Deadline 8 follow up submission

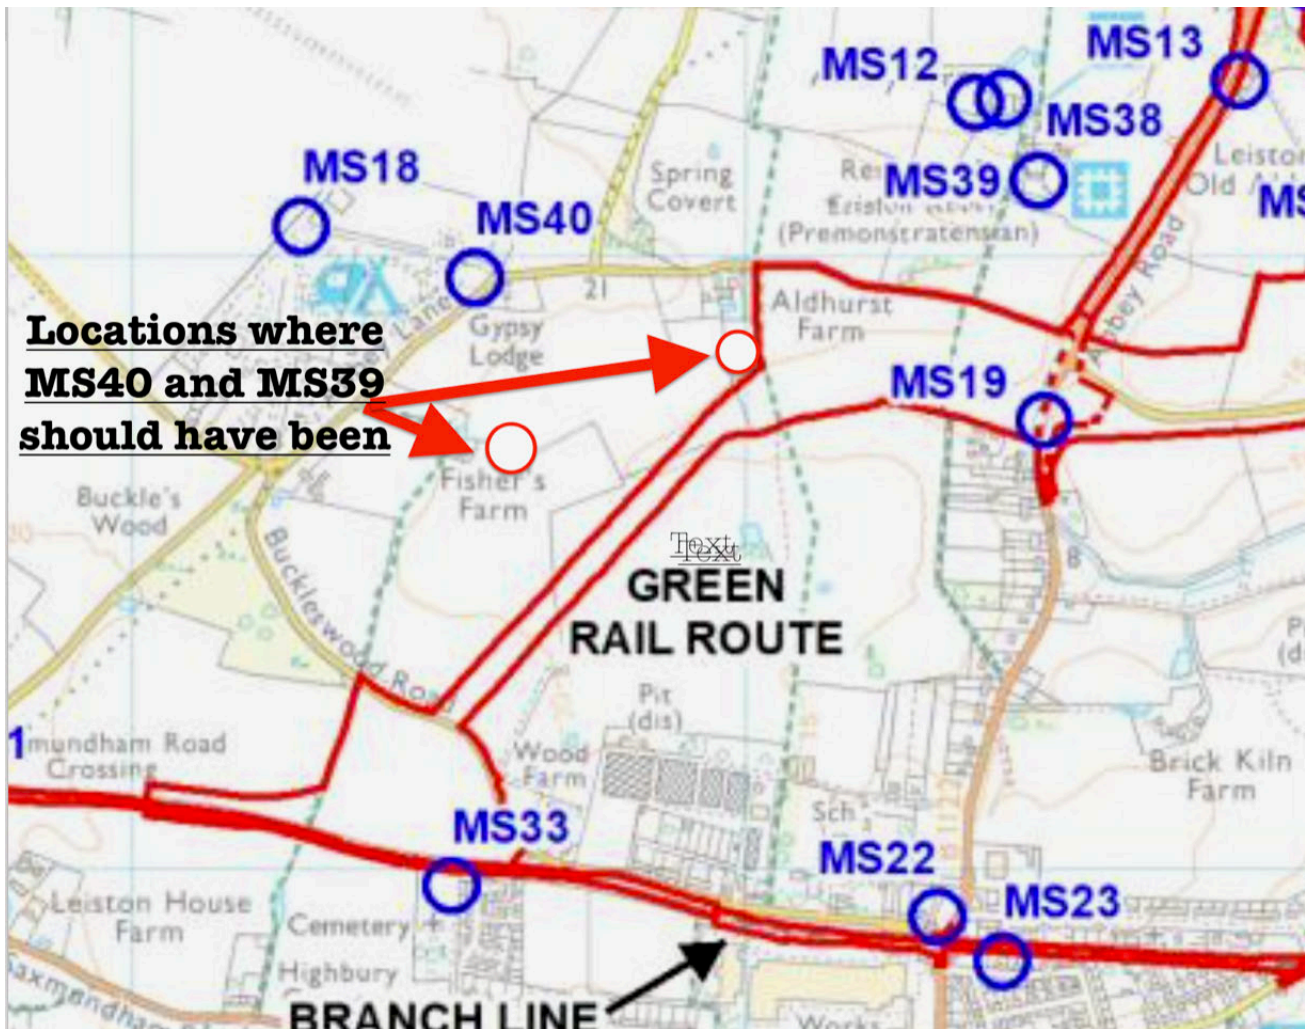
However all it seemed to achieve was a widening in our opposing stances and galvanised my view that both the methodology and results of their modelling were inaccurate and flawed. The two main points discussed were that that the two Monitoring Stations (MS40 & MS39)used to form a baseline level for the Green Rail Route (GRR) west of Abbey road were in the wrong positions giving false misleading data and that the noise contours produced for later years night-time Rail extension section showed anomalies which Mr Brownstone was unable to give a credible explanation to . We discussed also the use of the Nord 2000 module in SoundplanTM which I am of the view which will better show the devastatingly negative impact of noise to those along the GRR. Mr Brownstone agreed he would provide this as soon as he was able to , a relatively simple task by running the already inputted data along with wind speed and direction into the Nord 2000 module of SoundPlanTM. As of today's date nothing has been forthcoming from Mr Brownstone . I would ask the Inspectorate to see if they are able to request this from the applicant .

MS39 while suitable for a secondary location is not suitable for a primary one its proximity to both Abbey lane and Abbey road both of which are at a point when engine noise increases Abbey road where traffic exits Leistons 30mph limit and entering Abbey lane also exiting a 30mph zone additionally there is an incline travelling west at the start of the lane past MS12 increasing engine noise further. MS40 is also only suitable as a secondary location not as a primary one . It is furthest away from the GRR with Abbey lane running adjacent to it . The readings also were taken at its busiest time in peak season when the Park is at capacity and coinciding with the Harvest in the surrounding fields. The worst time to collect data to have any accurate meaning . Both graphs clearly show the biasing of the road traffic noise at peak times in both the morning and evening . Also to note for this section of the GRR three other MS locations all further away from the GRR MS12 MS18 and MS38.

Going onto my second point with the anomalies present in the noise contours produced for the night time rail extension section firstly the smoothing is far to coarse and three bands is not sufficient to illustrate the noise impact . The swollen lump as projected at the Abbey lane crossing intersection is a result of the elevation to the track at the crossing and as a consequence the spread of noise. A similar shape should be produced at the elevated section nearest my residence however incredibly by some sonic force field the noise merely laps up to but falls short of my house and neighbours but goes past in-between ! This simply highlights the inadequacy of the modelling . There are other counts on other contours which I discussed with Mr Brownstone and I think it would be prudent for all the data to be audited independently for its accuracy.

To summarise it is imperative that the applicant makes a firm commitment to re survey the area at the earliest possible opportunity to assess the proposed route correctly and mitigate impacts at any point with adequate Acoustic absorbent defences to absolutely minimise any negative noise impact . We must remember there is no existing rail route here to set any precedence and impact should be treated with the utmost sensitivity . Thank you for considering this submission.
